DOCKETED	
Docket Number:	23-AFC-03
Project Title:	Black Rock Geothermal Project (BRGP)
TN #:	257275
Document Title:	Black Rock Geothermal LLC Responses the The LV Equity Technical Advisory Group Comments on the ICAPCD PDOC
Description:	N/A
Filer:	Lindsey Xayachack
Organization:	Jacobs
Submitter Role:	Applicant Consultant
Submission Date:	6/21/2024 12:56:08 PM
Docketed Date:	6/21/2024

RE: **Selected Responses to The LV Equity Technical Advisory Group Comments on Preliminary Determination of Compliance for the Black Rock Geothermal Plant**

Figure I.4-1
Comparison of Wind Roses
Black Rock Geothermal Project
 Imperial County, California

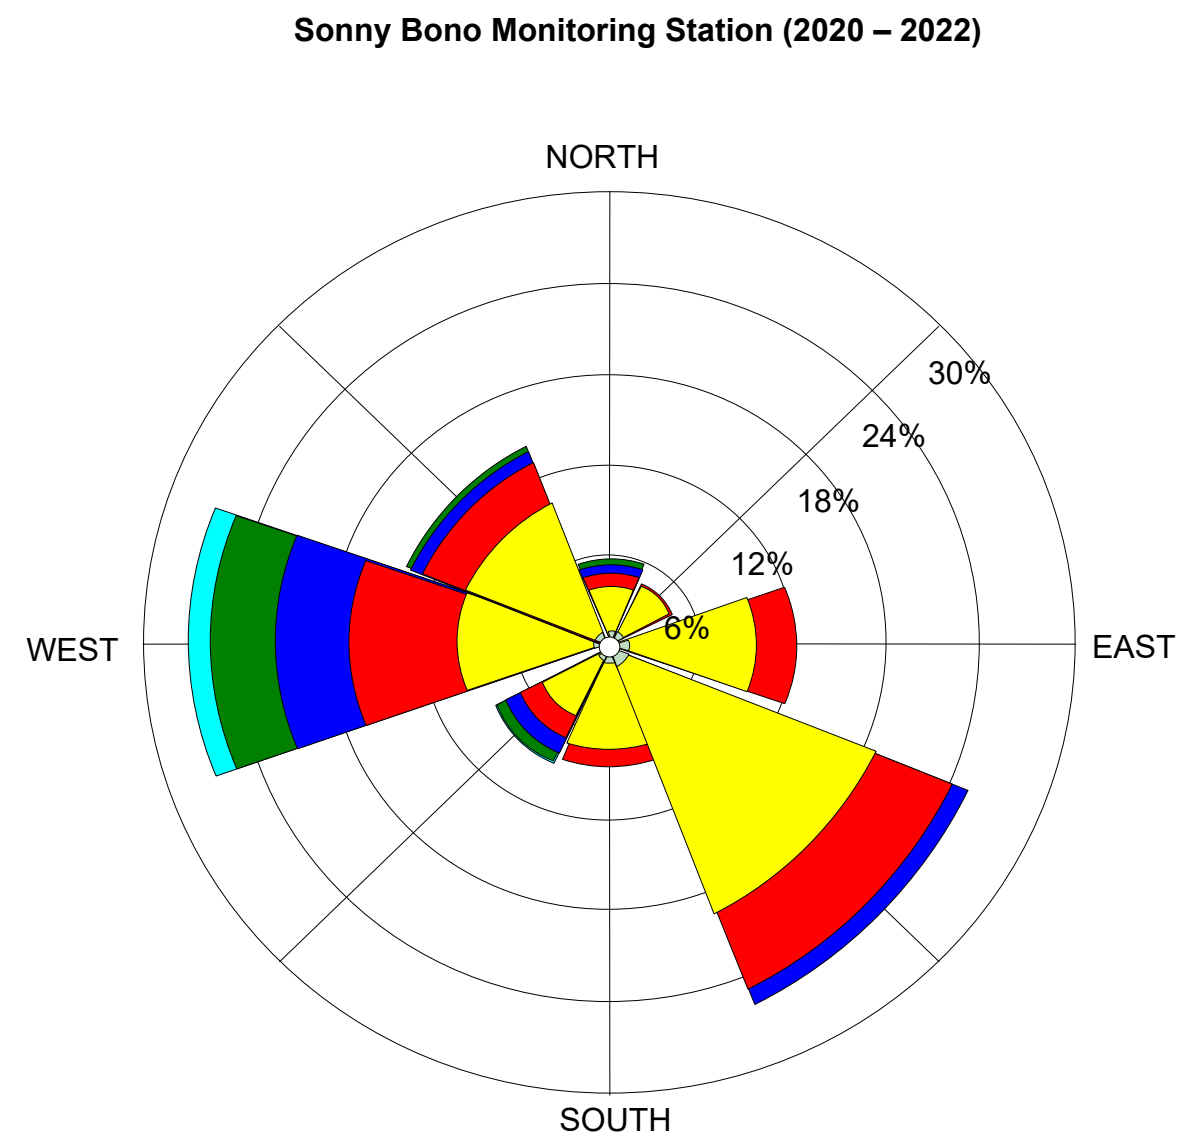
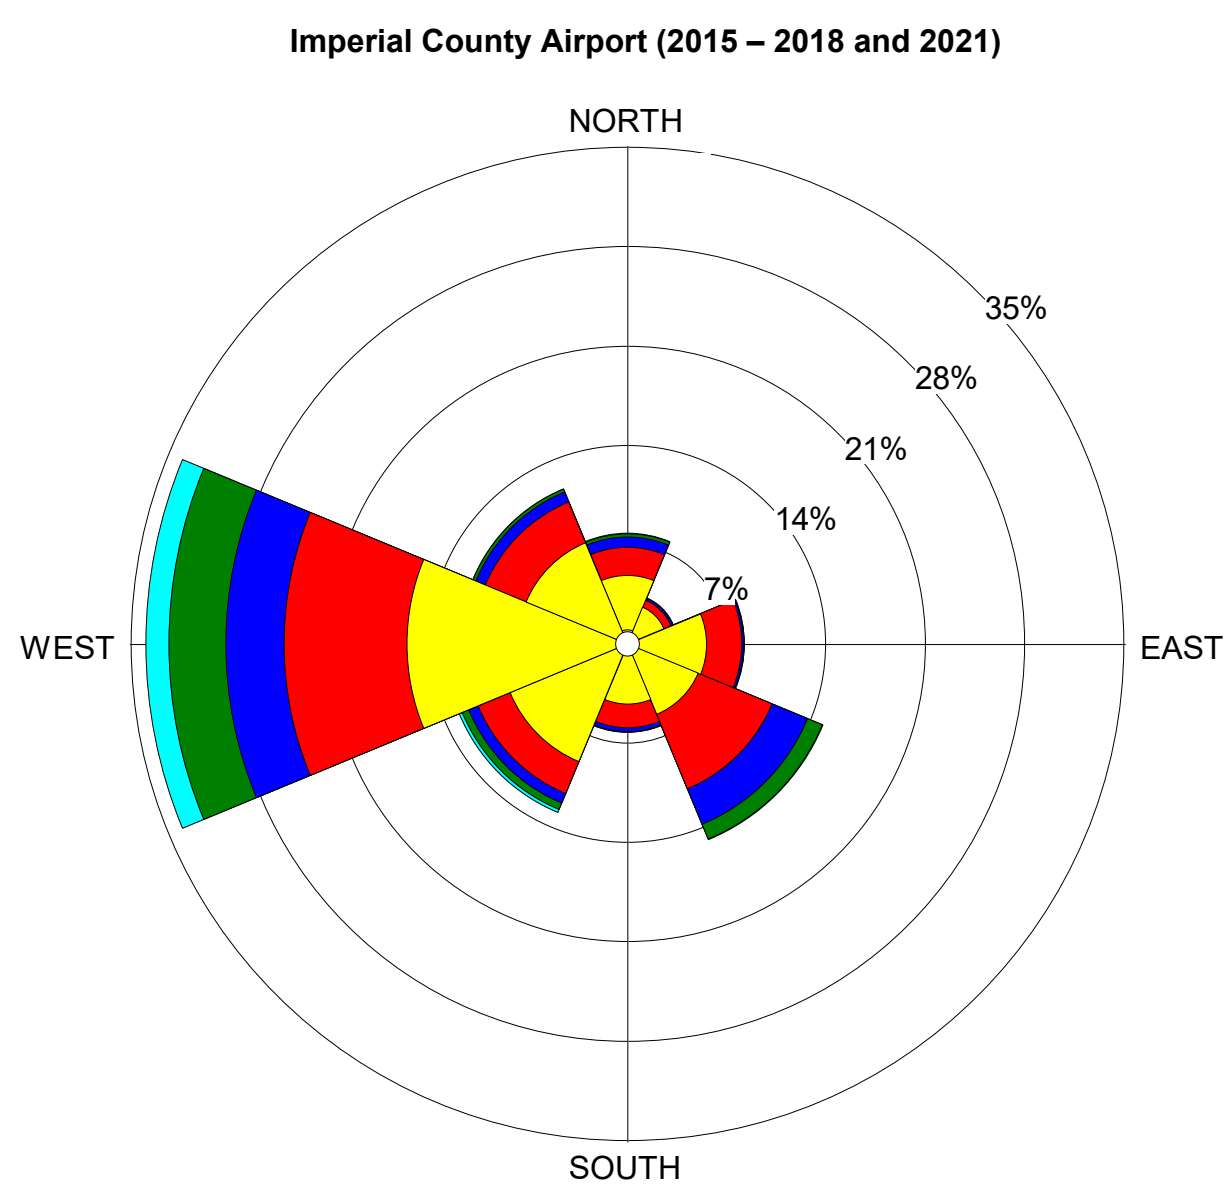
4. *Meteorological data should be representative of the proposed project site, for example using the Sonny Bono monitoring station and/or Comite Civico del Valle's IVAN air monitoring network. The current analysis relies on distant data from an Airport that is many miles away from the project site, as California Unions for Reliable Energy (CURE) recently pointed out in relation to the proposed Elmore North project.*²

Response: The dispersion model utilized the most representative, accurate, and reliable meteorological data available, consistent with EPA Guidelines. In particular, the Applicant reviewed the meteorological data collected at the Sonny Bono monitoring station and found that only two years of recent data (2020 and 2022) from that station meet the EPA requirements of 90 percent minimum completeness before substitution on a quarterly basis.¹⁰ To ensure the worst-case meteorological conditions are adequately represented in the model results, the EPA requires the use of five years of adequately representative National Weather Service (NWS) meteorological data, at least one year of site-specific data, or at least three years of prognostic meteorological data.¹¹

In addition, the Sonny Bono monitoring station is not an Automated Surface Observing Systems (ASOS) station, unlike the Imperial County Airport NWS station. ASOS stations are those monitoring stations which collect sub-hourly 1 to 5-minute wind speed and wind direction readings. To reduce the number of calms and missing winds in the surface data, archived 1-minute winds for the ASOS stations can be used to calculate hourly average wind speeds and wind directions, which are used to supplement the standard archive of hourly observed winds processed in the AERMOD Meteorological Preprocessor (AERMET).

Lastly, although the Imperial County Airport is located over 25 miles from the project site, there are no significant geographic features between the two locations, and both are located south/southeast of the Salton Sea. The lack of significant geographic features between the two locations is itself an indicator of representativeness of the Imperial County Airport meteorological data,¹² but also leads to the expectation that wind speeds and wind directions in the project vicinity are similar to those incurred at the Imperial County Airport. This expected similarity is verified by comparing the wind rose for the Imperial County Airport (for years 2015 to 2018 and 2021) to the wind rose for the Sonny Bono monitoring station (for years 2020 to 2022). As shown in Figure I.4-1, attached hereto, both wind roses share the predominant wind directions from the west and southeast.

Based on the above, the meteorological data collected at the Sonny Bono monitoring station is not more suitable for modeling as the data does not meet the minimum requirements for completeness and would not be any more representative of the project site than the Imperial County Airport data based on a comparison of wind roses. Furthermore, as an ASOS station, the Imperial County Airport NWS station may provide fewer missing hours of wind speeds and wind directions. For

these reasons, the Applicant supports the continued use of the Imperial County Airport NWS station meteorological data, as previously approved both by the ICAPCD and CEC.
